Addendum No. 2 – Mexico Beach Pier

November 10, 2025

6 PILASTER SECTION AT MIDSPAN
1" = 1'-0"

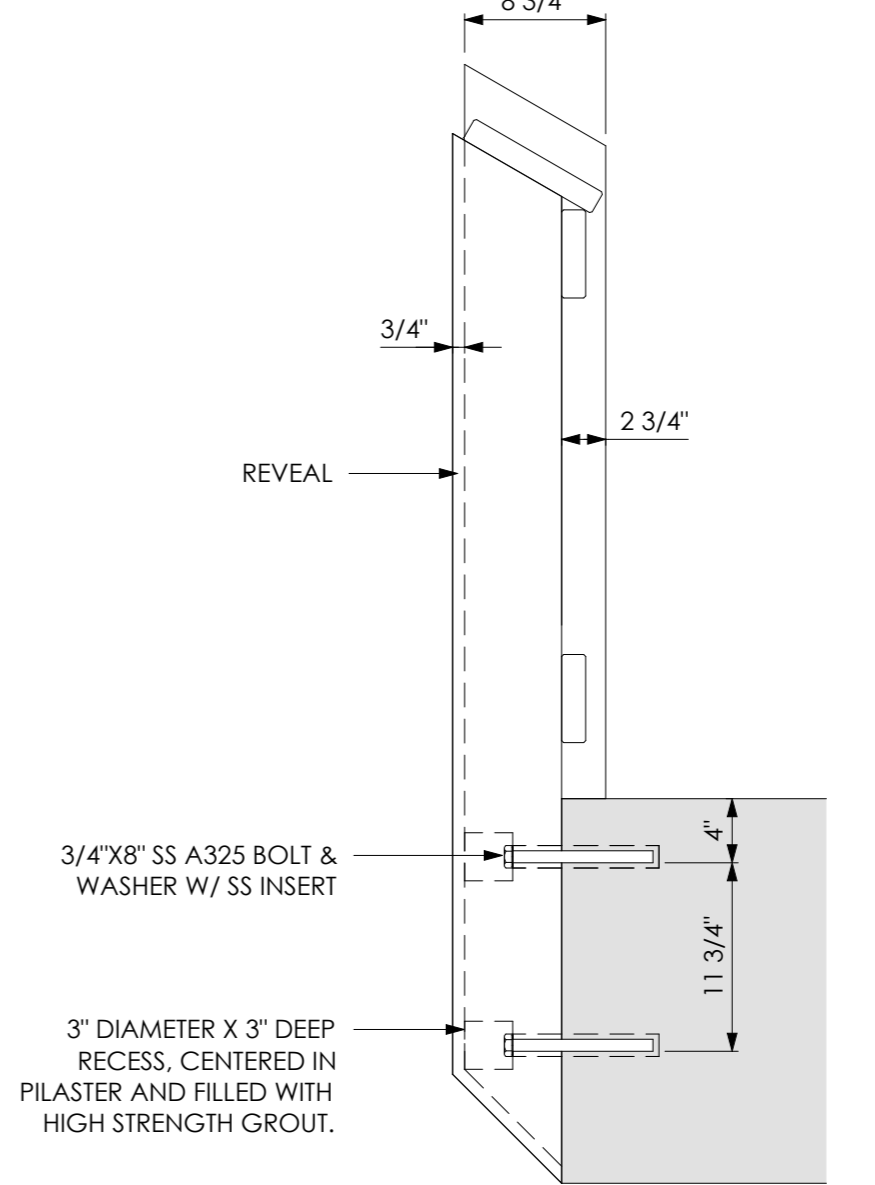
7. As I interpret it, the mid-span pilasters are to be cast-in-place. However, there are no details regarding the required rebar. Could this be provided?

8. Regarding same mid-span pilasters, which bid item should these be included in? Are they considered part of the handrail system (bid item 11) or the pile caps (bid item 8)?

Mid span pilasters will be reinforced with 4 - #5 bars (one bar per corner) and # 4 ties at 6" (10 req'd) for each pilaster. They would be considered part of the handrail system.

They will be considered part of the handrail system.

1 RESTROOM ELEVATION - BACK
1/2" = 1'-0"

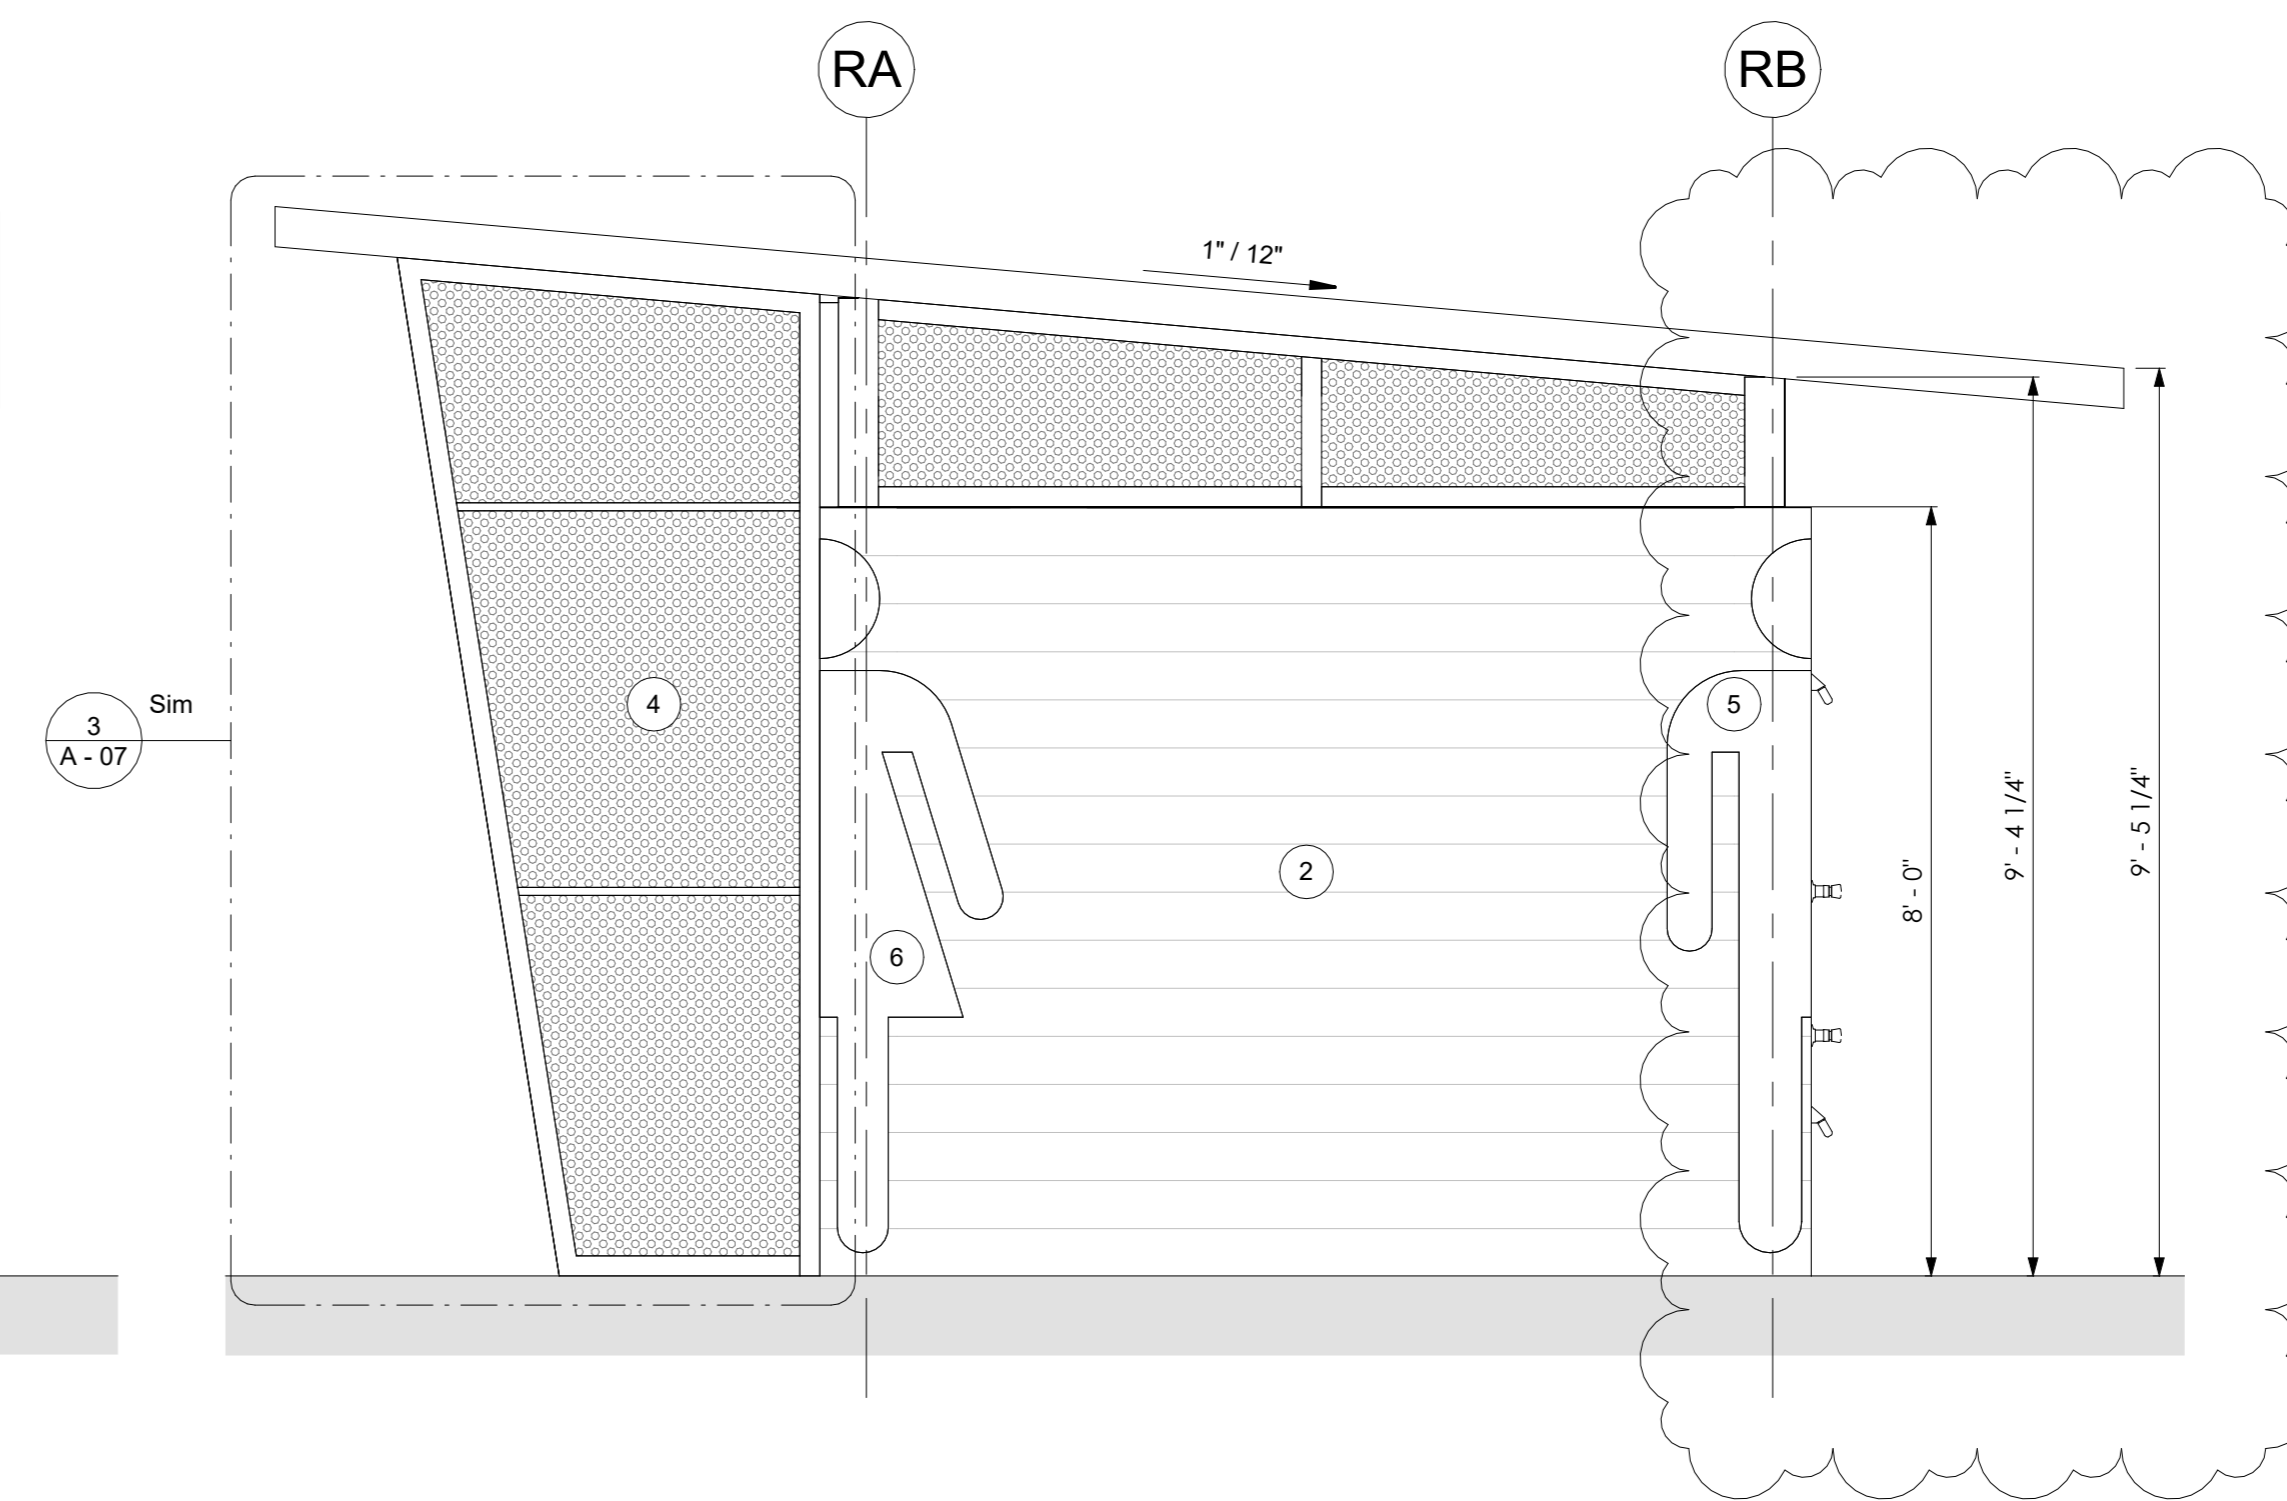
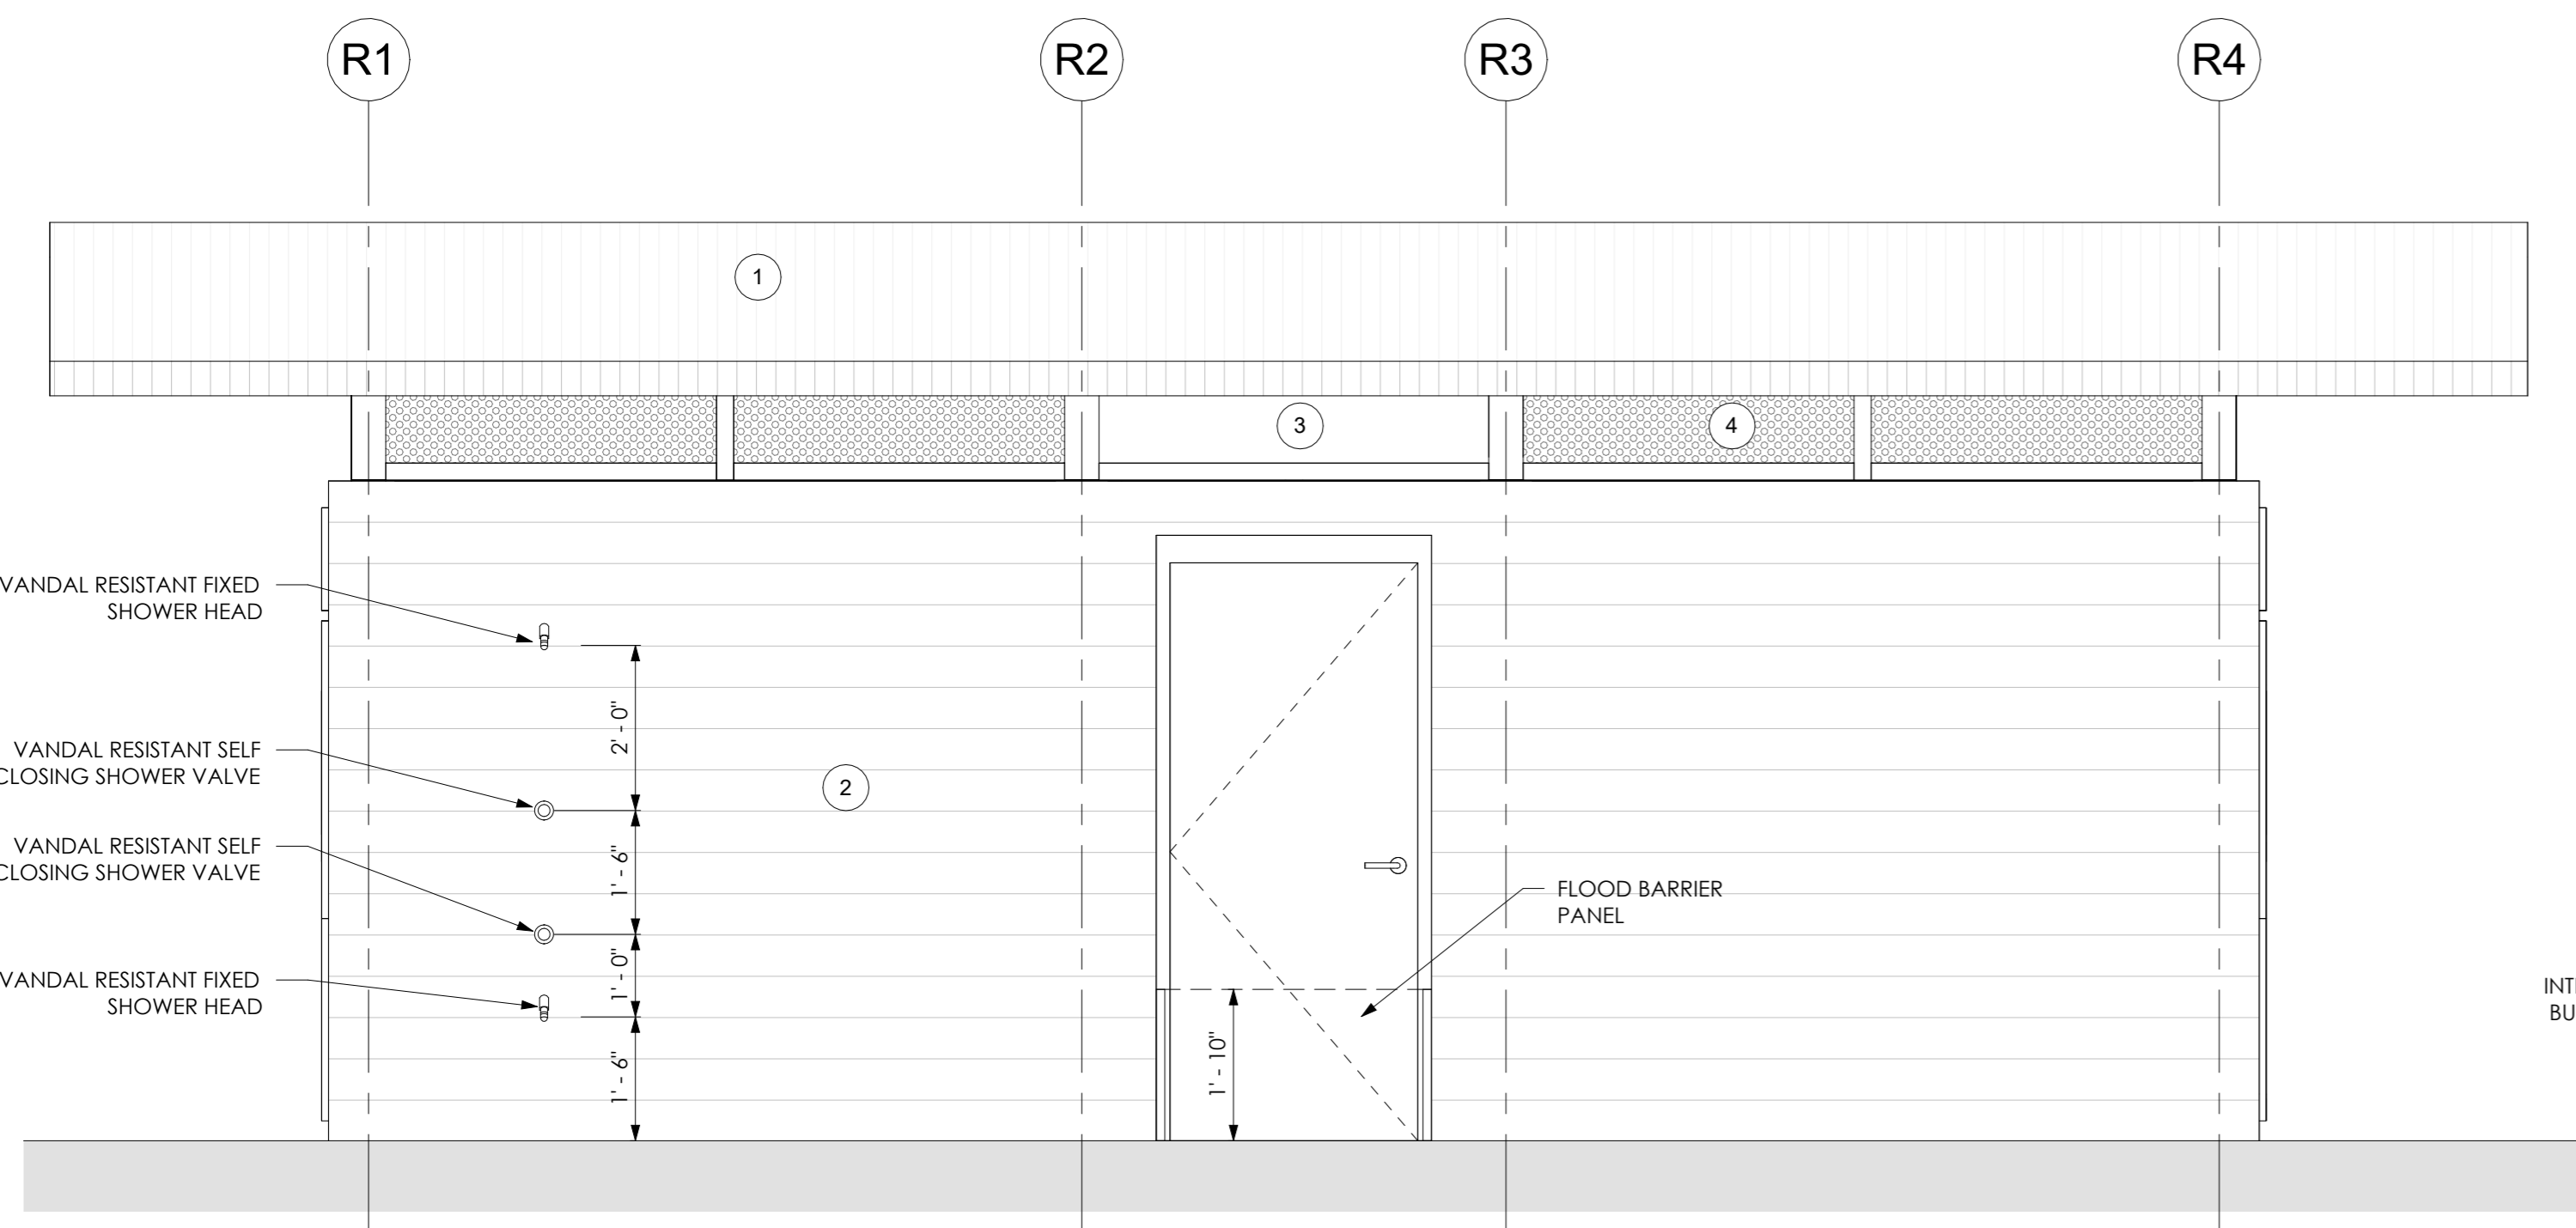
14. Plans for the restrooms call for aluminum and SS roof. Please clarify which roof is preferred.

15. There are no heights on the elevations for the restrooms. Please provide elevation dimensions for the restrooms.

Please see the revised Architectural Plans.

Please see the revised Architectural Plans.
